Product Change Notification

Change Notification #: 108547 - 01
Change Title: Intel(R) IP Network Server NSC2U, PCN 108547-01, Product Design, Revised IDE cable fold and Boot Bank Selection Jumper standard shunt, Reason for Revision: Update TA revision numbers
Date of Publication: January 12, 2009

Location of IDE cable and BBSJ on a NSC2U server with the top cover removed.

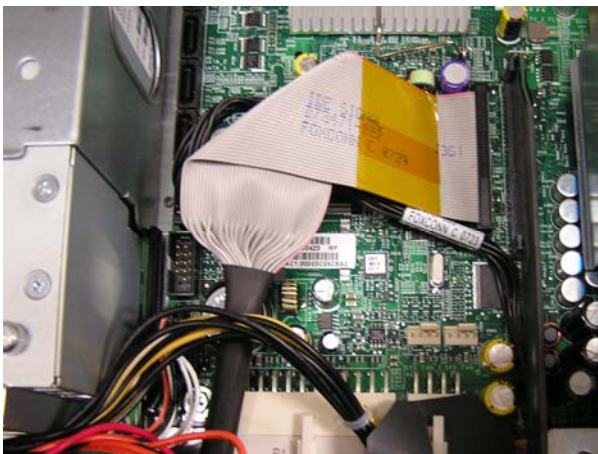
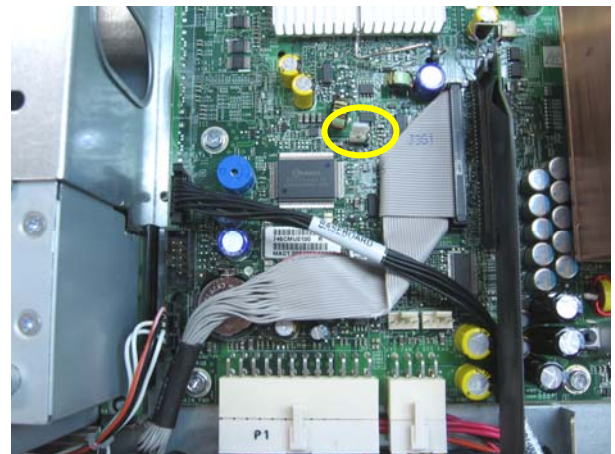
Intel has revised the fold of the IDE cable and removed the tab from the BIOS Bank Select Jumper (BBSJ) to minimize cable intrusion into the PCI keep-out zone.

The photos on the left show the original IDE cable fold with the cable routed over the top of the BBSJ and the USB cable.

The photos on the right show the revised fold and routing. The result of the revised cable routing and fold the IDE cable rests closer to the system board. The BBSJ is exposed and highlighted by a yellow circle.

Original cable fold

Revised cable fold

Close up of original IDE fold & BBSJ

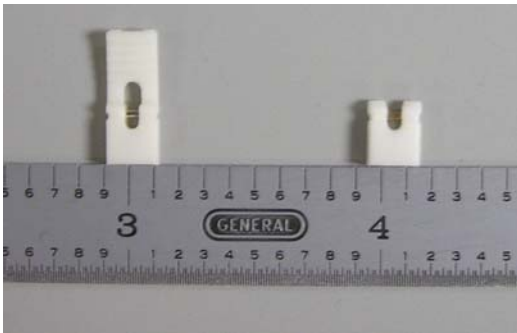
Close up of revised IDE cable fold & original BBSJ

The tab on the original shunt is designed to improve shunt access in the event the position must be changed. The tab-less shunt is a standard shunt used in electronic equipment. The BBSJ is accessed only in the event of a corrupted or failed BIOS update process. Corruption of a BIOS bank is a rare occurrence hence the BBSJ is seldom used.
